Access Compliance Report

Public Rights-of-Way

(Curb Ramps)

Intersection ID: N/A	Main Street: RIDGE_OAK_DR	Cross Street: SHADOW_RIDGE_LN	Location: NW
ADA ID: DE57C18697D8	Ramp Type: Perp	Initial Pass/Fail: Fail	Overall Compliance: No
Severity Score: 37.5			
Codes/Mitigation Info/Possible Solution		Field Measurements/Component Compliance

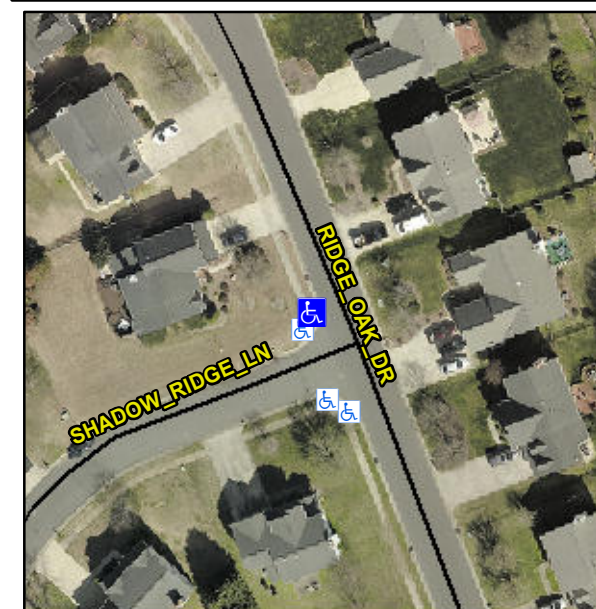
R304.5.1, R304.2.2, R304.5.3, R302.7

Compliance	Description	Data	Compliance	Description	Data
N/A	Ramp Length (in)	71.0	No	Ramp Slope (%)	8.6
No	Ramp Width (in)	40.0	No	Ramp XSlope (%)	2.7
N/A	Flare Type LT	N/A	N/A	Flare Type RT	N/A
N/A	Flare Slope LT (%)	N/A	N/A	Flare Slope RT (%)	N/A
N/A	Flare Traversable LT?	N/A	N/A	Flare Traversable RT?	N/A
N/A	Landing Length (in)	N/A	N/A	DWS Provided?	N/A
N/A	Landing Width (in)	N/A	N/A	DWS Contrast?	N/A
N/A	Landing Slope (%)	N/A	N/A	DWS Length (in)	N/A
N/A	Landing X Slope (%)	N/A	N/A	DWS Full Width?	N/A
N/A	Landing Curb? (Y/N)	N/A	N/A	DWS Offset (in)	N/A
N/A	Shared Landing?	N/A			
N/A	Gutter Ponding?	N/A	N/A	Gutter Slope (%)	N/A
N/A	Gutter Lip Ht (in)	N/A	N/A	Gutter X Slope (%)	N/A
N/A	Painted X Walk1?	No	N/A	Painted X Walk2?	N/A
	X Walk 1 Direction	To NE		X Walk 2 Direction	N/A
N/A	X Walk 1 Width (in)	N/A	N/A	X Walk 2 Width (in)	N/A
	X Walk 1 Slope (%)	0.3		X Walk 2 Slope (%)	N/A
	X Walk 1 X Slope (%)	1.2		X Walk 2 X Slope (%)	N/A

N/A	Ramp inside XWalk1?	N/A	N/A	Ramp inside XWalk2?	N/A
	Road Slope (%)	N/A	N/A	Clear Space?	N/A
	Road X Slope (%)	N/A	N/A	Clear Space to XWalk (in)	N/A
N/A	Any Obstructions?	N/A	N/A	Storm Grate/Utility Hazard?	N/A
	Obstruction Type			Storm Grate/Utility Type	
		N/A			N/A
		No		Surface Condition? (G/P)	Poor

Remove & Replace Entire Ramp.
